NO.	DATE	REMARKS	BY
REVISIONS			
		CASCO BAY STEEL STRUCTURES ONE WALLACE AVENUE SOUTH PORTLAND, ME 04106 PHONE: 207-780-6722 FAX: 207-780-6726	
STRUCTURE <u>BENMONT AVE. (TH-7) (URBAN MINOR ARTERIAL)</u>			
LOCATION <u>TOWN OF BENNINGTON, VERMONT</u>			
PROJECT NO. <u>BRIDGE NO. 57 PROJECT NO. BRF 1000(16)</u>			
ENGINEER <u>STATE OF VERMONT AGENCY OF TRANSPORTATION</u>			
CUSTOMER <u>ALPINE CONSTRUCTION</u>			
ITEM <u>GIRDER ~ 12G2C</u>			
SURFACE PREP. <u>SSPC-SP10</u> OPEN HOLES <u>1/8" (UN)</u>			
PAINT <u>NONE</u>			
APPROVAL	DRAWN <u>GDC</u>	12-8-14	SHEET NO. <u>12AB</u>
SHOP	CHECKED <u>FM</u>	1-6-15	JOB NO. <u>605</u>

Sheet 12AB - Prepared: 01/09/2015 @ 08:39 (HEBERT)

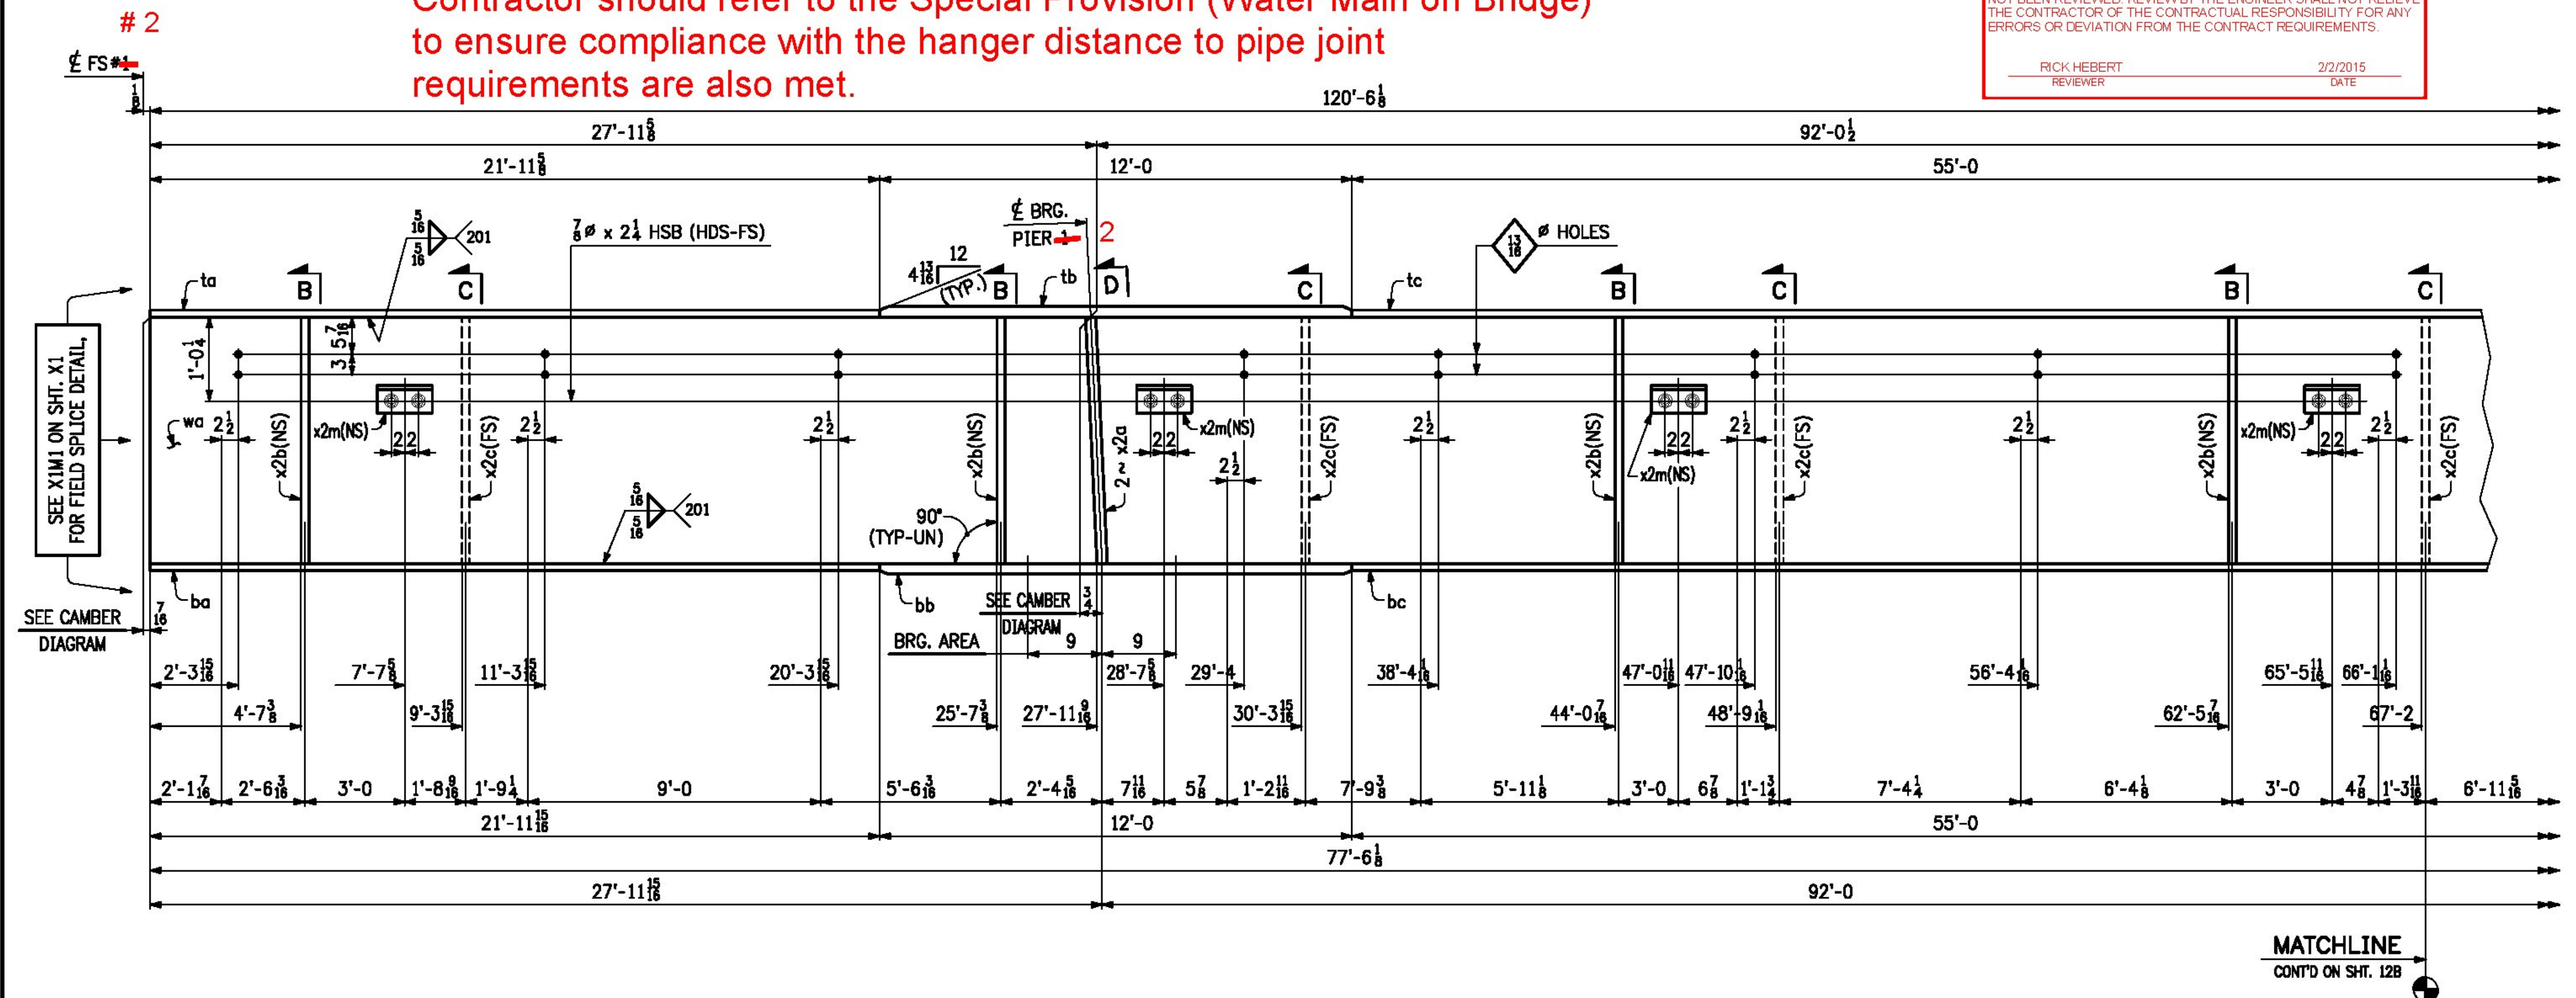
Spacing of waterline support beams are not all at 9'-0" spaces as shown on Contract Drawing Sheet 39 of 75. Maximum variation appears to be 9". The increase in span is acceptable, however the Contractor should refer to the Special Provision (Water Main on Bridge) to ensure compliance with the hanger distance to pipe joint requirements are also met.
